PERMIT

This is to certify that Fowle Florence E/Advanced Building & W... Company
has permission to Add 10' x 12' Sunroom
AT 2 Parkside Condo 167 H001002

PERMIT ISSUED		Permit No: 02-0745	Issue Date: 07/10/2002	CBL: 167 H001002
----------------------	--	--------------------	------------------------	------------------

Location of Construction: 2 Parkside Condo / 59 Johanson St	Owner Name: Fowle Florence E	Owner Address: 59 Johanson St Unit 2	Phone: 207-772-3028
Business Name: n/a	Contractor Name: Advanced Siding & Window, Comp	Contractor Address: 335 RT 125 Brentwood	Phone: 6036792844
Lessee/Buyer's Name: n/a	Phone: n/a	Permit Type: Additions - Dwellings	Zone: RS

Revised sketch

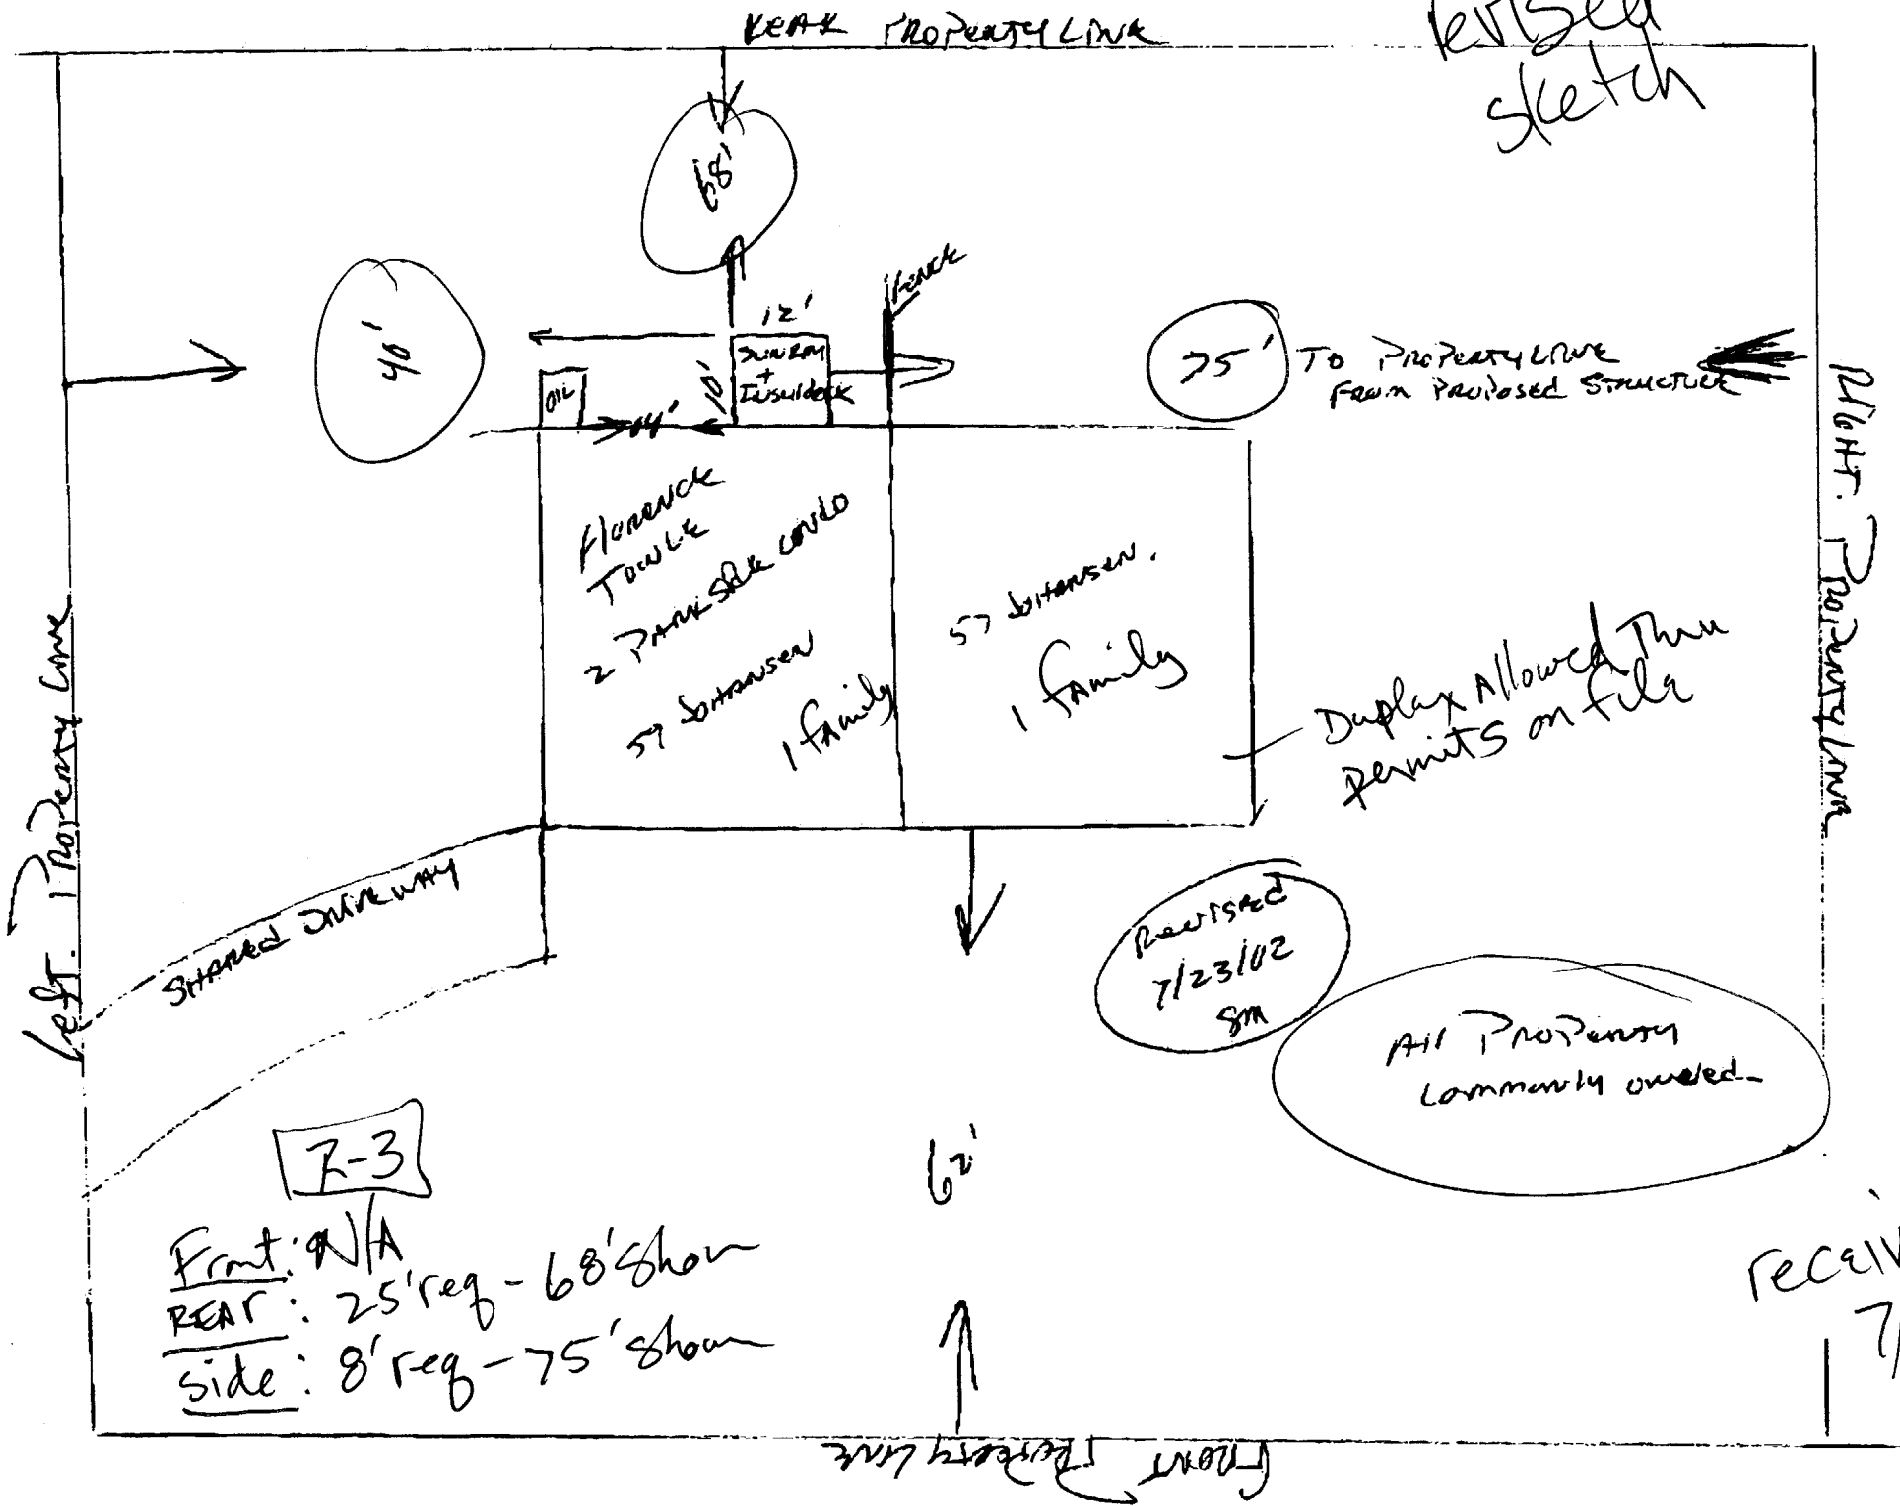
Comments: 07/22/2002 - R-3 zone requ. 8' setback and only 4' shown - left message for owner- she deferred to contractor
7/24/02 received revised plans from contractor - shows more than the required 8' to the side setbacks

Steve, you probably should redraw your
submittal with the changes -

This approval is based upon the revised plans submitted that show 8 foot plus for a side setback.

Front: N/A
REAR: 25' req - 68' shown
Side: 8' req - 75' shown

Panelized 10' x 12' Insul-Deck Floor System

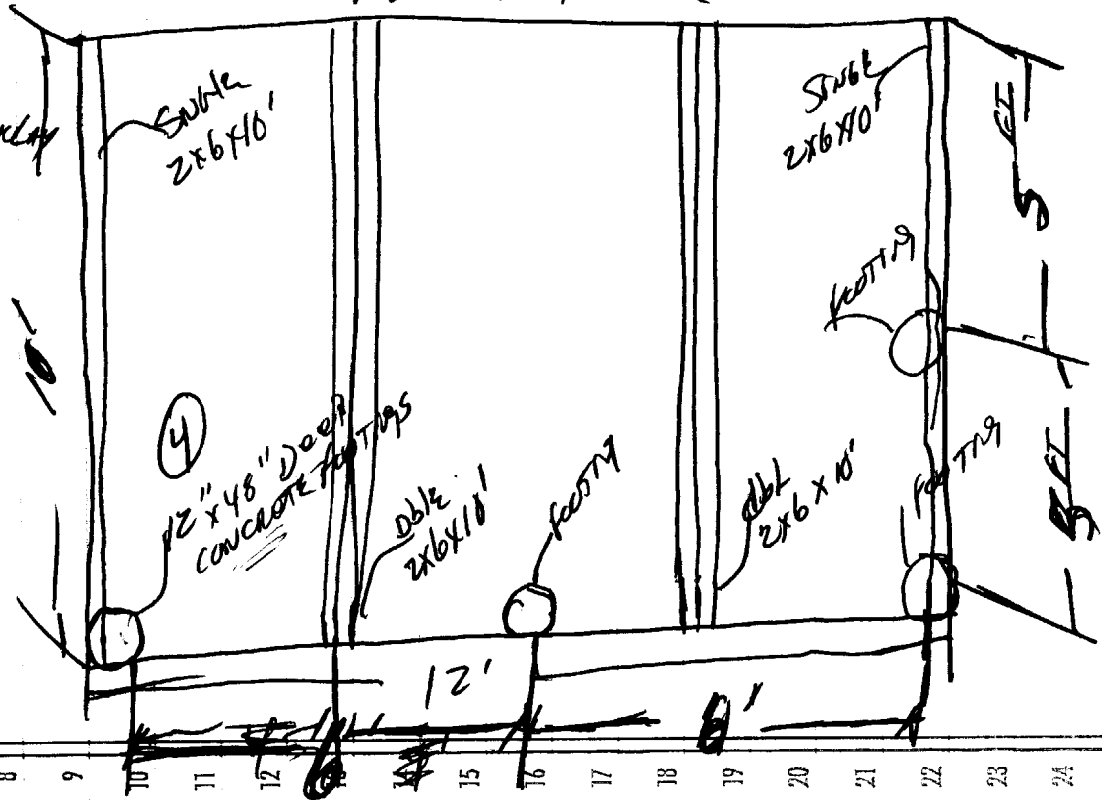
07/31/2002 Floor system fails to meet acceptable span/spacing, Contractor notified MJN.
